APPROVED MINUTES OF THE MEETING

May 17, 2012

Project: Fred Hutchinson Skybridge
Phase: Skybridge
Last Reviewed: Mar 15, 2012; Jun 16, 2011
Presenters: Rich Hill, McCullough Hill Leary, PS
Scott Rusch, Fred Hutchison Cancer Research Center
Allyn Stellmacher, ZGF
Marni Heffron, Heffron Transportation

SKYBRIDGE IMPROVEMENT PACKAGE F, G

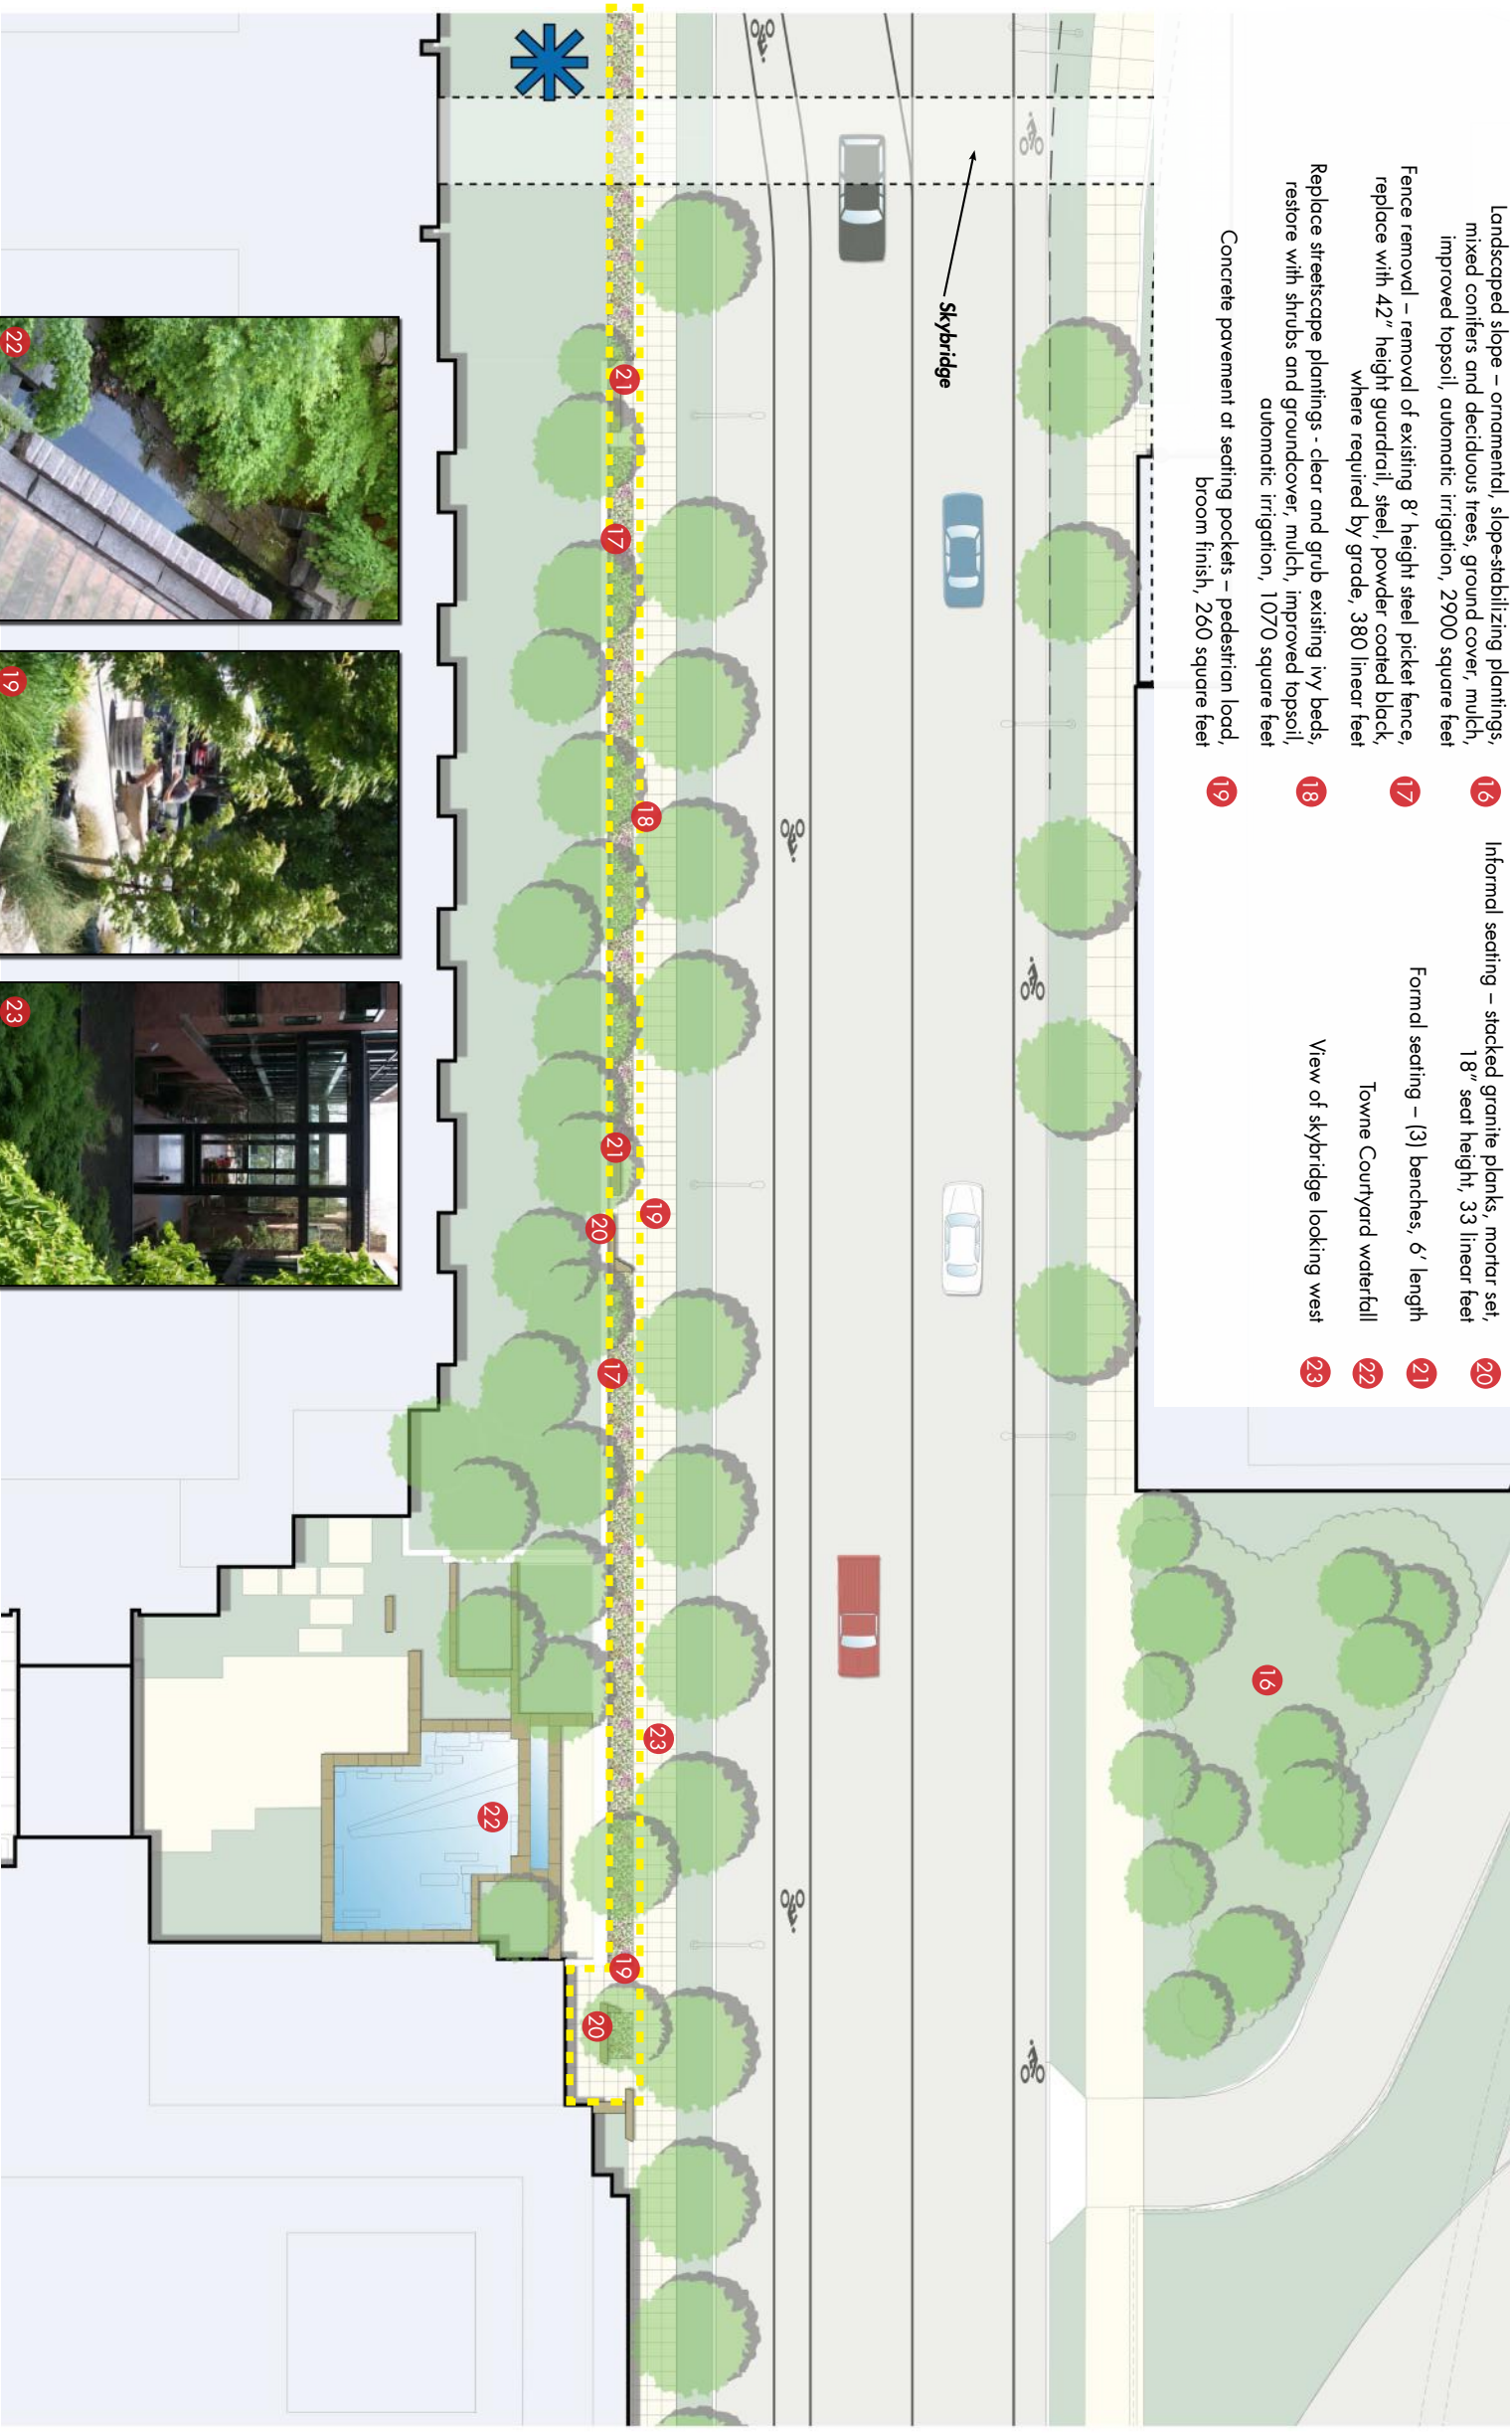
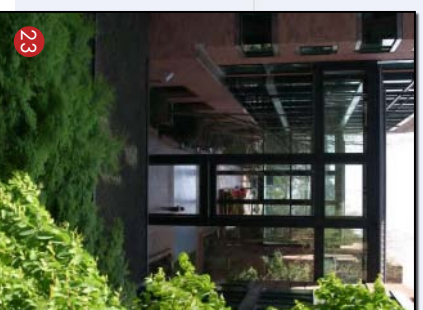
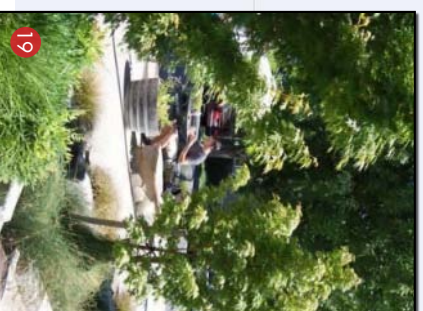
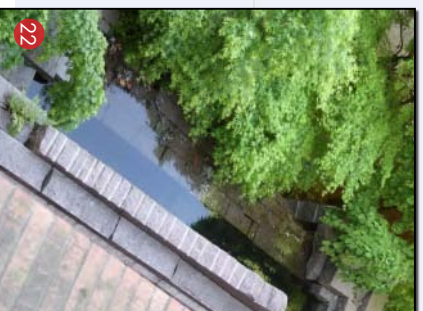
- Refine the design, purpose, and maintenance of the WSDOT triangle. Better define its features and who maintains it. If the WSDOT triangle is piece of a larger system of nearby open space, such as the Colonnade trail, show its integration.
- Refine the scope, design and placement of the art. The budget is small, especially for two pieces, and the locations are not the best. Consider investing in a single piece, and making the scale of the piece relate to those traveling by bus, bicycle and car.
- Make generous and public the entrances to the hillclimb. Design them so the public will want to use them, feel safe, and have views.
- Locate benches in smart places, such as at the bus stop, where people will use them.
